Part Number: **A063D152** Part Revision: **D**
 Part Name: **ARRANGEMENT, GENERATOR GENERAL**
 Drawing Category: **Detail** State: **Released** Sheet 1 of 2

| Change Notice | CN00108733 | Alternates | |

Part Number: A063D152

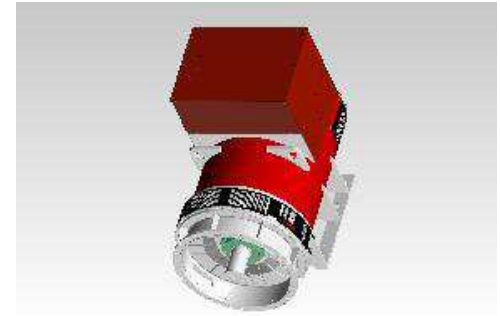
| <p>Description of Change(s) Note: Change information is provided for reference only and does not supersede the drawing's primary content.</p> <p>DRAWING - NOTE AMENDED TO READ 32 HOLES IN ADAPTER MATING FLANGE (WAS 16). ANGULAR POSITIONS OF HOLES (SAE POSITIONS) CLARIFIED.</p> <p>PART - ADAPTER PART NUMBER WAS 760-10083 (SAE00 / 16-HOLES), NOW 760-10640 (SAE00 / 32-HOLES).</p> |
